HISTORIC AND DESIGN REVIEW COMMISSION

July 15, 2020

HDRC CASE NO: 2020-201
COMMON NAME: 335 TRAIL
LEGAL DESCRIPTION: NCB 6078 BLK 2 LOTS 9 THRU 14 & 17 THRU 20
ZONING: MF-33, RIO-1, H
CITY COUNCIL DIST.: 1
DISTRICT: River Road Historic District
TYPE OF WORK: Consideration and action of an application for a multi-unit residential development:

Item B: The applicant is requesting a Certificate of Appropriateness for approval to construct a multi-unit residential development (23 units) on the vacant lot located at 335 Trail. The property features lots that are located within the River Improvement Overlay only, as well as those that are located within both the River Improvement Overlay and the River Road Historic District. The applicant has proposed for the residential structures to feature two and three stories in height. Access to the site will be provided from Trail Street and Huisache Street. A revised parking proposal is included in this request.

BUILDING 4 ELEVATIONS

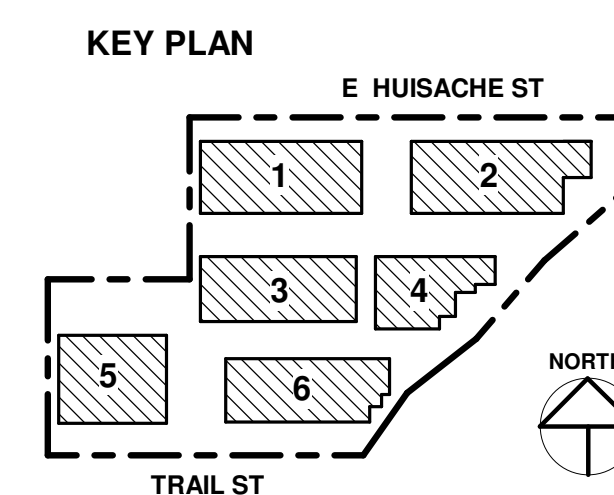
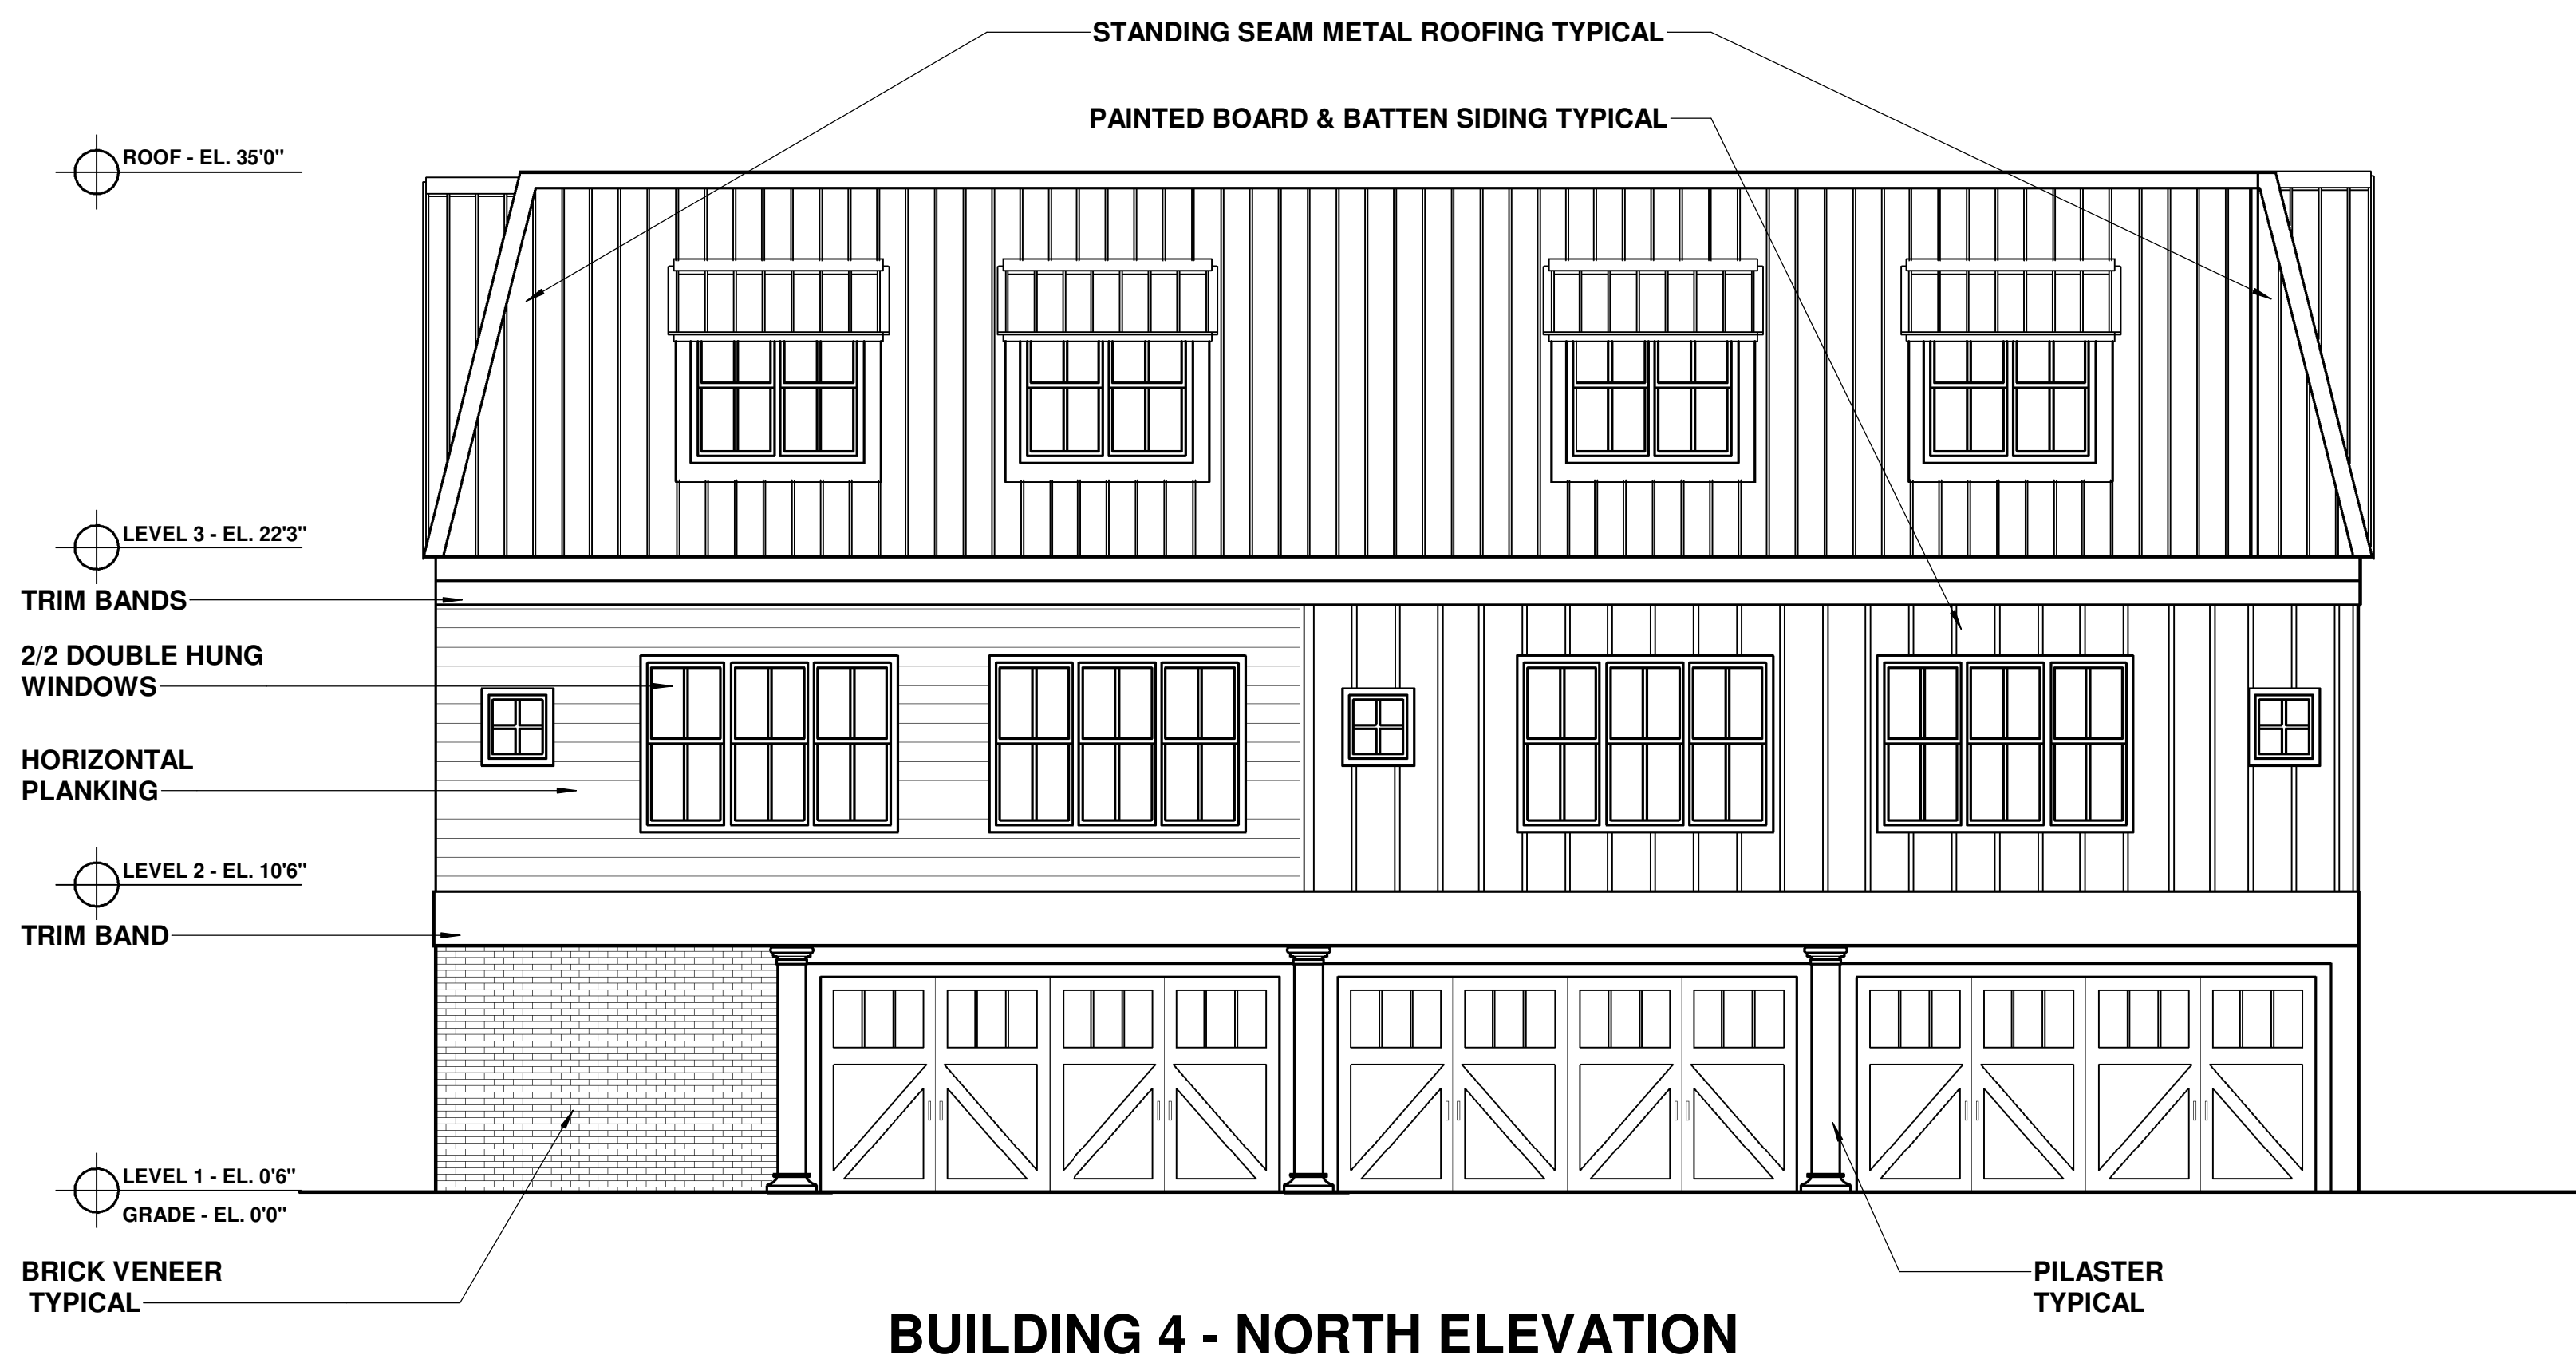
- l. **PROXIMITY TO ACEQUIA** – The applicant has proposed a setback of fifteen (15) feet from building 4 to the acequia, as well as a setback of more than fifteen (15) feet from building 6. While staff finds the increased setbacks to be appropriate; staff finds that additional steps must be taken to further protect the acequia. Staff finds that the applicant must submit a construction management plan. The construction management plan should outline the steps taken to protect the acequia throughout the course of construction. Moreover, the formal construction plans should identify no subsurface work (utilities, grading, etc.) within 5 feet of the extant acequia. In-field protection of the acequia should include orange construction fencing and silt fencing at a buffer distance of 5 feet from the feature. No construction activities will occur within the buffer area. This fencing should be present on-site until construction is completed. As stated previously, the acequia shall not be used for storm water drainage. Furthermore, the acequia shall not be used for storage, equipment cleaning, or any other use during development that could impact the feature.
